**ADDRESS: 239 CHESTNUT ST**

Proposal: Construct seven-story building

Review Requested: Review In Concept

**MEETING OF THE ARCHITECTURAL COMMITTEE  
OF THE PHILADELPHIA HISTORICAL COMMISSION**

Figure 1: 239 and 241 Chestnut Street from Baxter's Panoramic Directory, 1879. Image courtesy of the Athenaeum of Philadelphia.

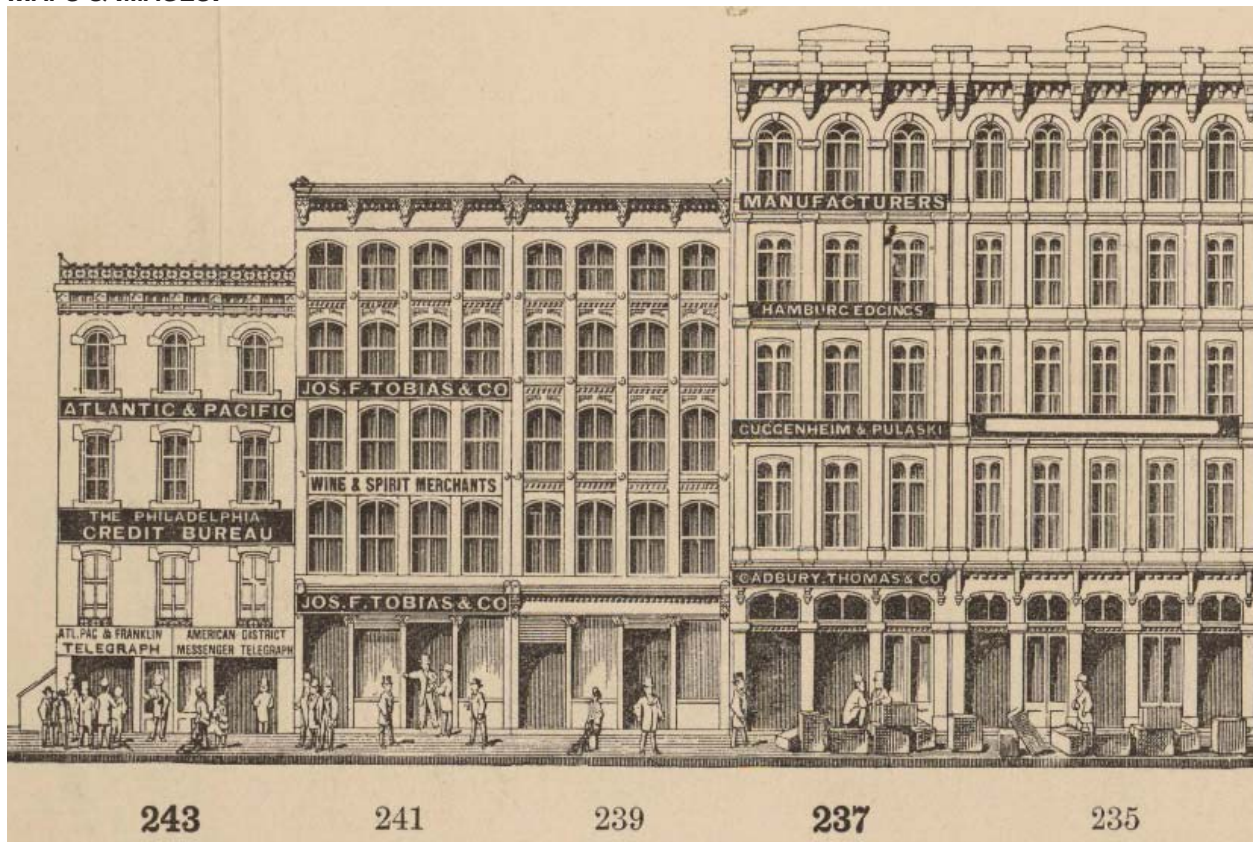
- The front façade of the proposed building would not match its twin to the west at 241 Chestnut Street, even though very complete documentary evidence exists for the reconstruction. The project does not comply with this standard.

- The architectural features of the proposed front façade will not be compatible with the environment, especially the adjacent twin building at 241 Chestnut Street. The project does not comply with this standard.
